# UNITED STATES PATENT AND TRADEMARK OFFICE

<b>Office Action Summary</b>	<b>Application No.</b> 10/560,832	<b>Applicant(s)</b> KAMATA ET AL.	
	<b>Examiner</b> Albert Hilton	<b>Art Unit</b> 1716

### DETAILED ACTION

**Claims 1-8 are rejected under 35 U.S.C. 103(a) as being unpatentable over Moen (US Patent No. 3273757).**

Diagram 1, reproduced with modification from Moen, Fig. 2.

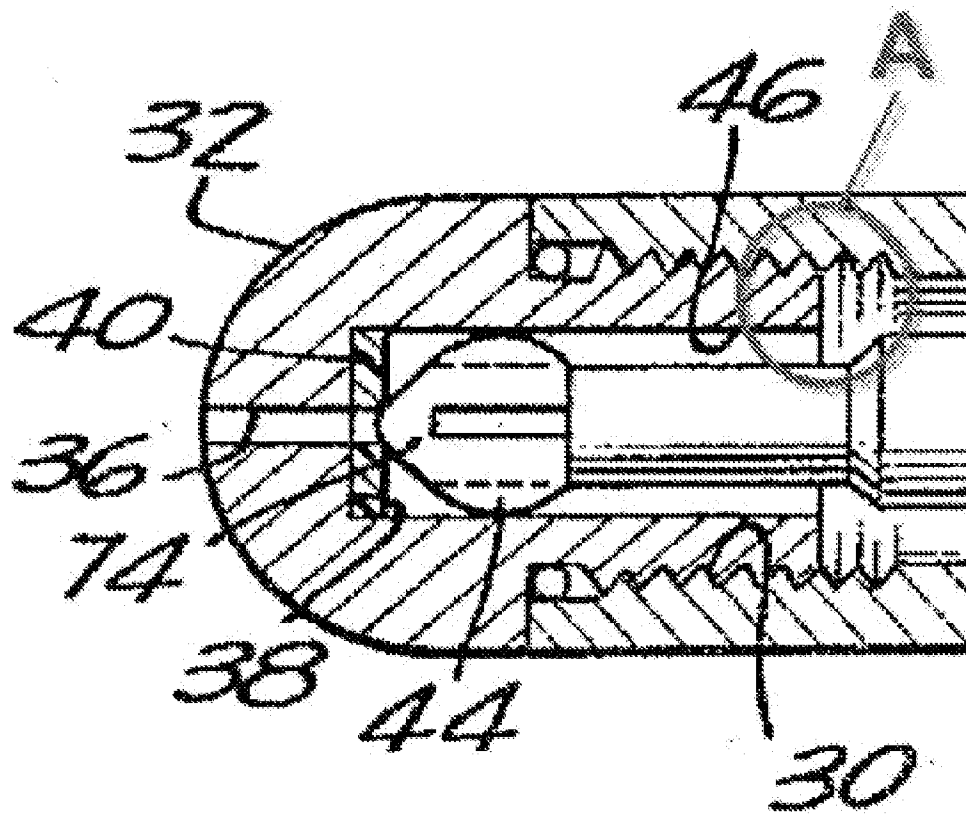
3. Regarding claim 1, Moen describes a nozzle (**liquid dispenser 10**) comprising a receiver (**spool 56**); a first nozzle part (**barrel 22**) formed in a cylindrical shape, the first nozzle part (**22**) communicating with the receiver (**56**), the first nozzle part (**22**) being coaxial with and separate from the receiver (**56**); and a second nozzle part (**tip insert**

**32)** formed in a cylindrical shape having an inner diameter smaller than that of the first nozzle part (**22**), and an outer diameter equal to that of the first nozzle part (**22**), the second nozzle part (**32**) being connected to the first nozzle part (**22**), wherein the second nozzle part (**32**) is disposed nearer to the coating object than the first nozzle part (**22**), and wherein between the first (**22**) and second (**32**) nozzle parts there is formed a step (see A in diagram 1 below) protruding from the inner surface of inwardly between the first nozzle part (**22**) toward the inside of and the second nozzle part (**32**) (Moen: column 4, lines 8-10, 33-35, and Fig. 2).

4. Further regarding claim 1, the first **(22)** and second **(32)** nozzle parts are not always in open communication with each other, as the connection between the two is sometimes blocked by a conical valve obturator **(74)** when the valve is in an opened position (Moen: column 5, lines 4-24 and Figs. 6, 10). Moen teaches that such a valve system functions to interrupt the flow of material and to prevent adhesive material dispensed from the nozzle from setting inside the nozzle.

5. However, the elimination of an element and its function does not distinguish a claimed invention from the prior art where said function is not desired (see MPEP 2144.04: Elimination of a Step or an Element and its Function). One of ordinary skill in the art at the time of the invention, desiring to use the nozzle of Moen to dispense a continuous flow of material, would therefore have found it obvious to remove the obturator **(74)**, with the ordinary and expected result that such a modification would allow for an uninterrupted flow of material.

6. Regarding claim 2, the step **(A)** is formed flat in a direction crossing at right angles in a direction in which the dispensed fluid flows in the first **(22)** and second **(32)** nozzle parts.

7. Regarding claim 3, the step **(A)** in the nozzle of Moen is formed flat in a direction crossing both a direction in which the dispensed fluid flows in the first **(22)** and second **(32)** nozzle parts and a direction crossing at right angles the direction in which the fluid flows.

8. Regarding claim 4, the step **(A)** in the nozzle of Moen is formed on the first nozzle part **(22)**.

9. Regarding claim 5, the first **(22)** and second **(32)** nozzle parts in the nozzle of Moen are connected coaxially with each other.

10. Regarding claims 6-8, Moen discloses a nozzle (**liquid dispenser 10**) comprising a first (**barrel 22**) and a second (**tip insert 32**) part (Moen: column 4, lines 8-10, and Fig. 2). Moen does not specify the precise ratio of the length (**L**) of the first part **(22)** to the length (**I**) of the second **(32)** part. However, the use of a first part **(22)** of length **L** and a second part **(32)** of length **I** such that  $8 \leq L/I \leq 10$  represents a mere change in the shape and proportion of the parts that would not alter the function of the nozzle in a patentably distinct way over the prior art (see MPEP 2141.01). One of ordinary skill in the art at the time of the invention would find it obvious that nozzles with a broad variety of different length ratios could be created. Similarly, while Moen does not disclose the precise ratio of the diameter (**D**) of the first part **(22)** to the diameter (**d**) of the second **(32)** part, one of ordinary skill in the art would find it obvious that nozzles satisfying the condition  $4 \leq D/d \leq 6$  could be used, as well as nozzles that simultaneously satisfy the conditions  $8 \leq L/I \leq 10$  and  $4 \leq D/d \leq 6$  without altering the function of the nozzle in a patentably distinct way over the prior art.
